LOUISIANA
POWER & LIGHT

SUBJECT: Waterford 3 Steam Electric Station
Docket No. 50-382
Construction Adequacy of WSES-3 Basemat

On Thursday, March 22, 1984, your staff informally requested that LP&L be prepared to respond to a list of thirty-two questions at a meeting in Bethesda, Maryland on March 26, 1984. Extensive efforts of key project personnel resulted in the preparation of draft responses to the questions, which were handed out at the March 26, 1984 meeting. However, as was indicated by our representatives at the meeting, due to the extent of the questions and the volume of our response, coupled with the extremely short response time (four days, including the weekend), we were not able to subject the responses to a thorough review prior to the meeting.

PROJECT WATERFORD UNIT #3

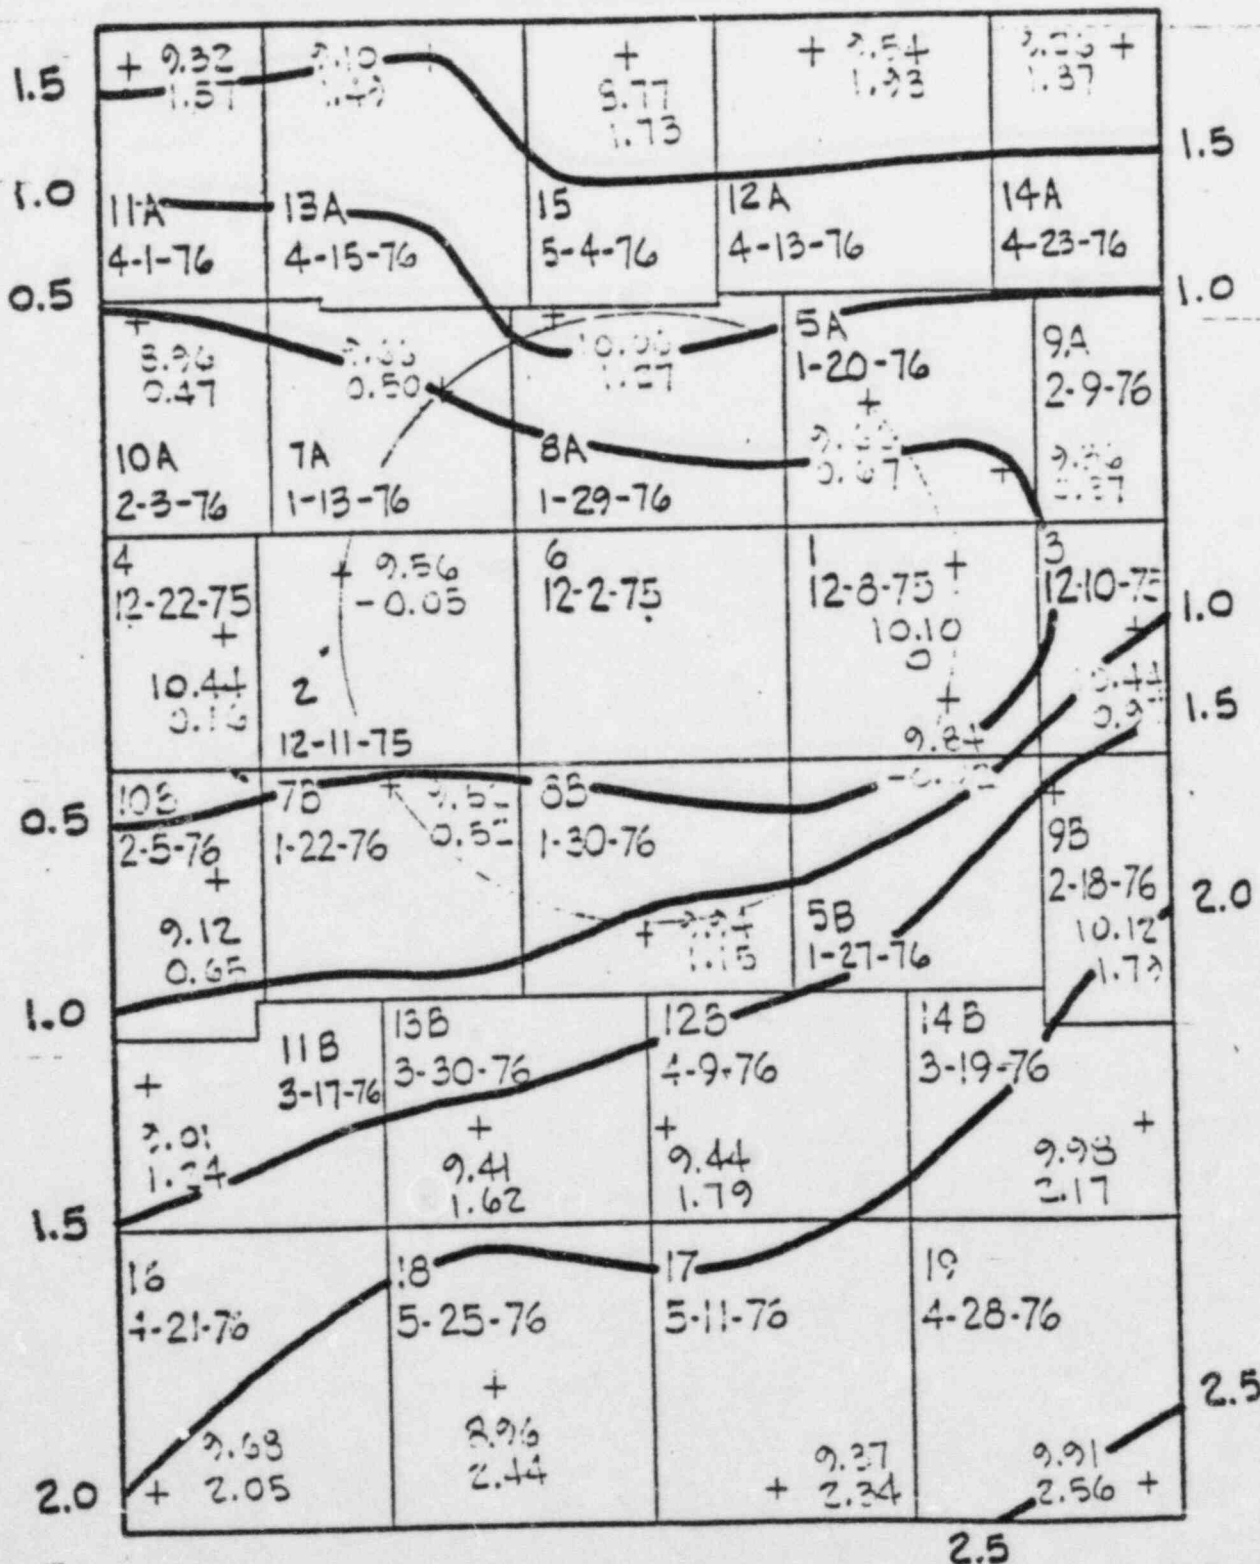
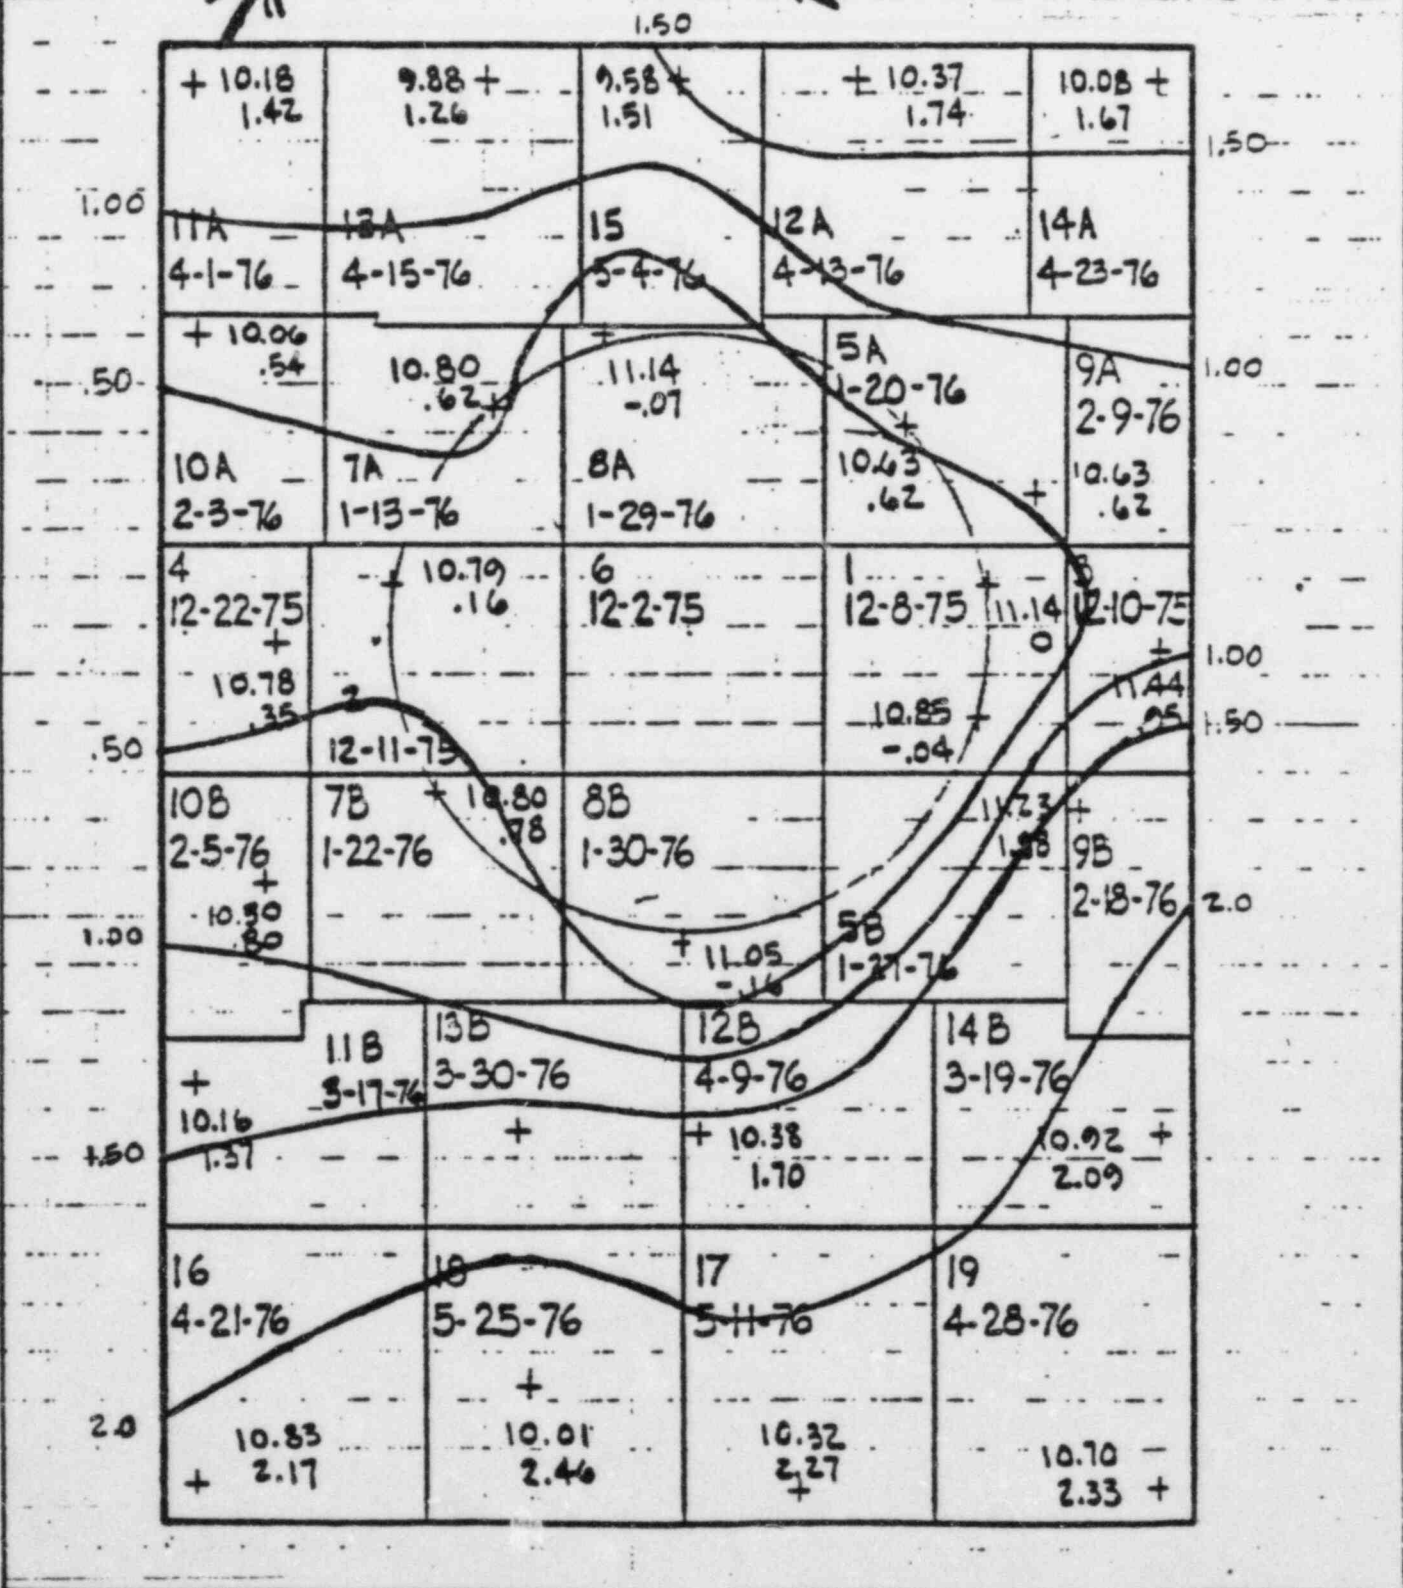
17. Provide differential settlement contours for 6 month periods, starting from early 1977 to present.

Response:
